INNER WEST COUNCIL

DEVELOPMENT ASSESSMENT REPORT

Application No.	D/2018/535
Address	13 Jane Street, BALMAIN NSW
Proposal	Part demolition and alterations and single storey addition to the rear of the existing heritage listed dwelling-house and associated works, including new pool in the rear garden, removal of trees and new fencing.
Date of Lodgement	11-Oct-2018
Applicant	Studio Prineas
Owner	Ms J A McCarthy and Mr J P Ockerby
Number of Submissions	First notification period: Objections from 5 properties Second notification period: Objections from 2 properties
Value of works	\$1,079,500
Reason for determination at Planning Panel	Extent of demolition within a Heritage Item
Main Issues	<ul style="list-style-type: none"> Impact to heritage item and conservation area Solar access Visual privacy
Recommendation	Approval
Attachment A	Recommended conditions of consent
Attachment B	Plans of proposed development
Attachment C	Statement of Heritage Significance – Subject site

Drawing Title
Timber Balustrade Details
Scale 1:10 @ A3
Drawn By JL
Date 25/02/2019

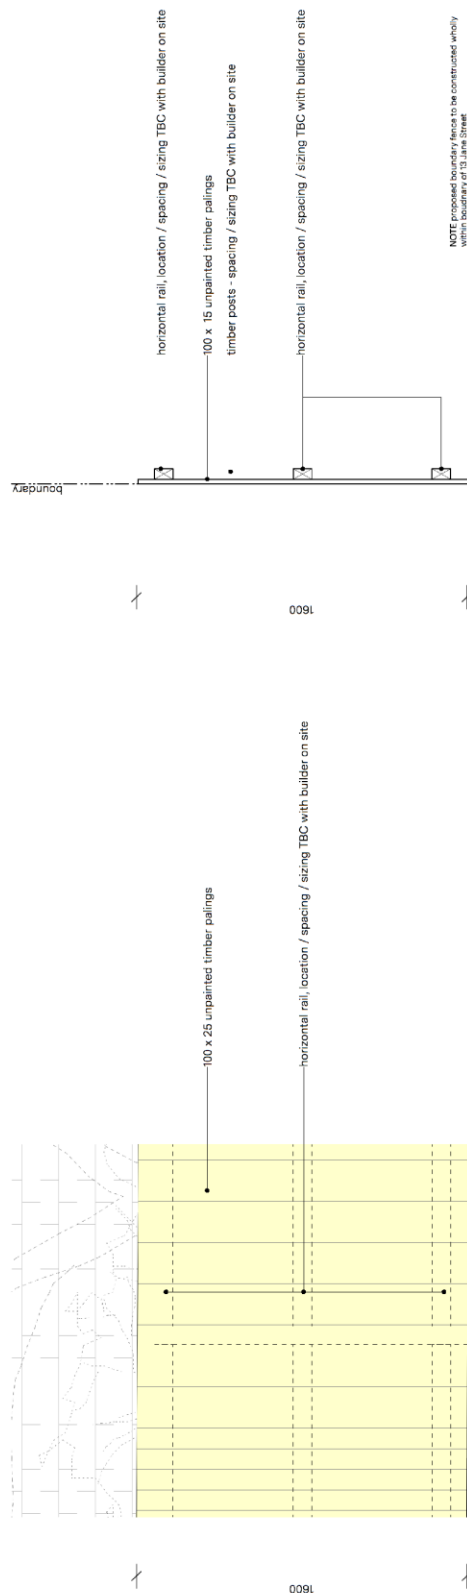
5. *The balustrade on the rear first floor verandah is to be timber in traditional detail.*

Comment: A detailed drawing has been provided proposing western red cedar, or equal, and to be painted Dulux Vivid White, or equal, which is acceptable.

Title Timber Paling Fence
Details
Scale 1:10 @ A3
Drawn By J.L.
Date 25/02/2019

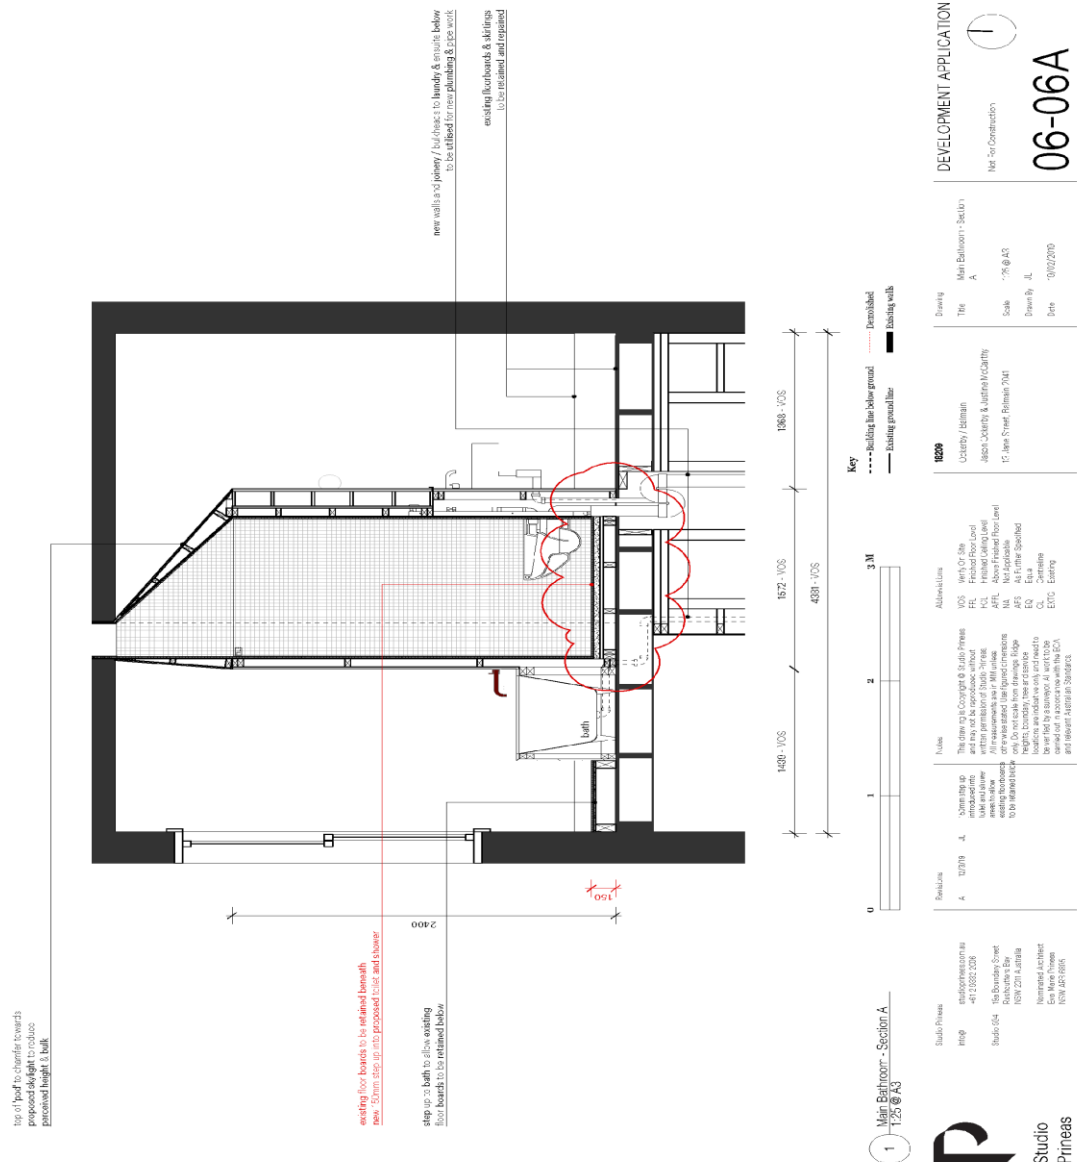
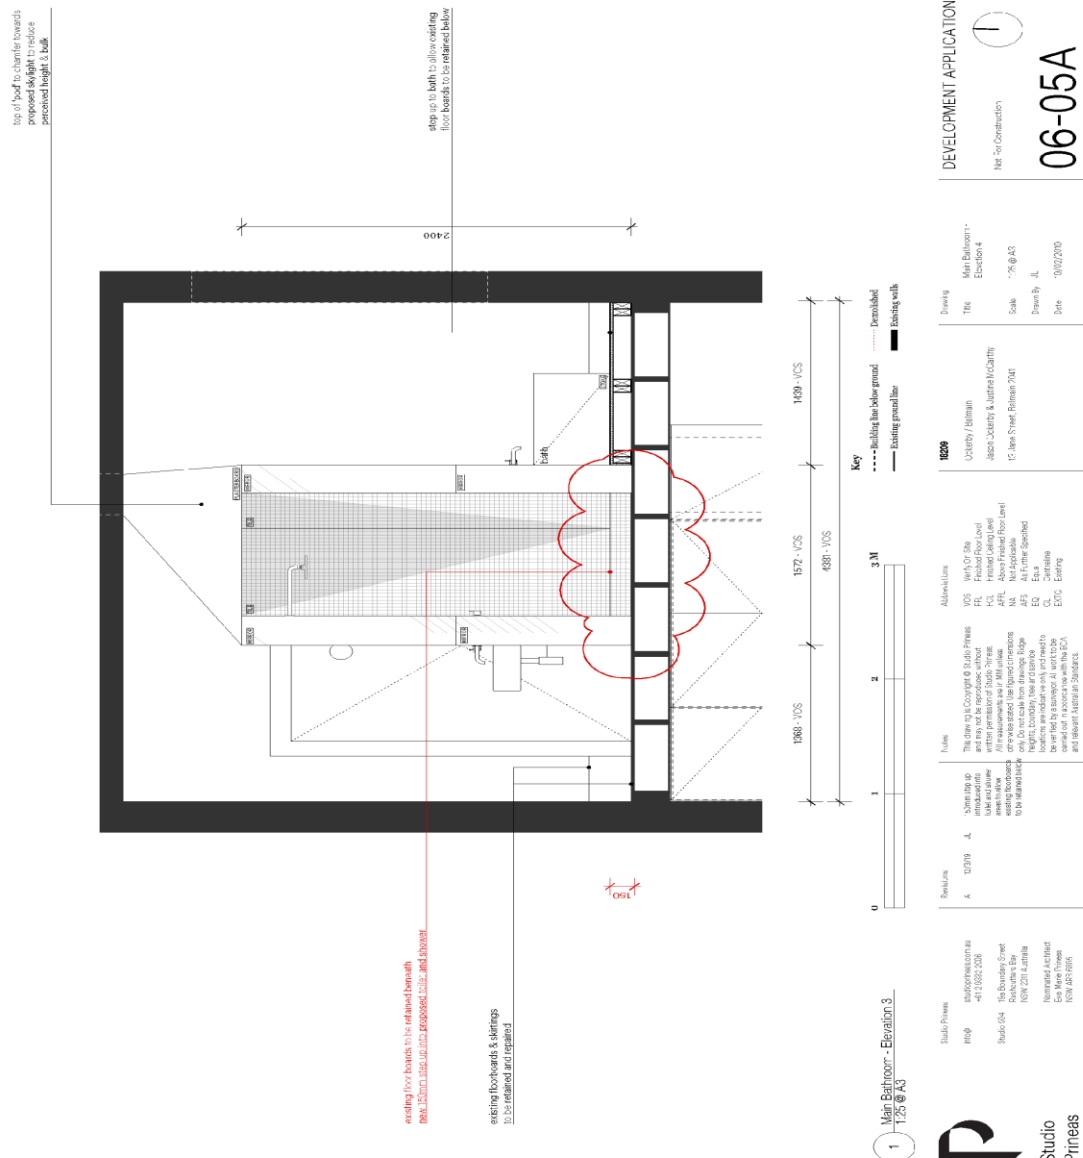
Comment: A detailed drawing has been provided for the proposed timber paling fence showing Northern Box, or equal, and to weather to a silver / grey, which is acceptable.

1 Main Bathroom - Elevation 3
1:25 @ A3

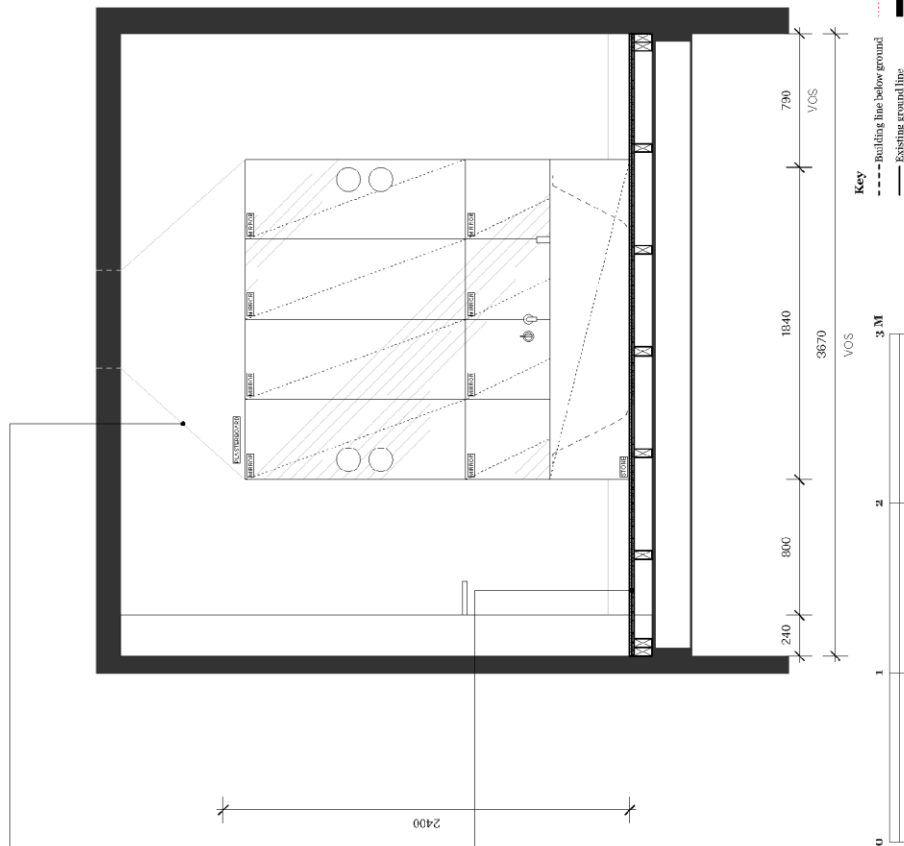
remove the existing floor boards in the central portion of the room to allow for the required set down for a flush finish between new tiles and existing floor boards. The bathroom is to be redesigned so that there is a step up to the bathroom pod, including bath, shower and toilet. The design is to ensure the existing floor boards in the central portion of the room are retained.

A skylight above the proposed bathroom has been added to the amended drawings, with a top of “pod” chamfer towards the proposed skylight to reduce the perceived height and bulk. This is a good design solution to reduce the bulk of the “pod” bathroom within the room. The skylight is acceptable as it will be in the rear roof plane.

Comment: The revised main bathroom drawings now include a 150mm step up to the proposed bath, toilet and shower so the existing floor boards are retained below, which is acceptable.
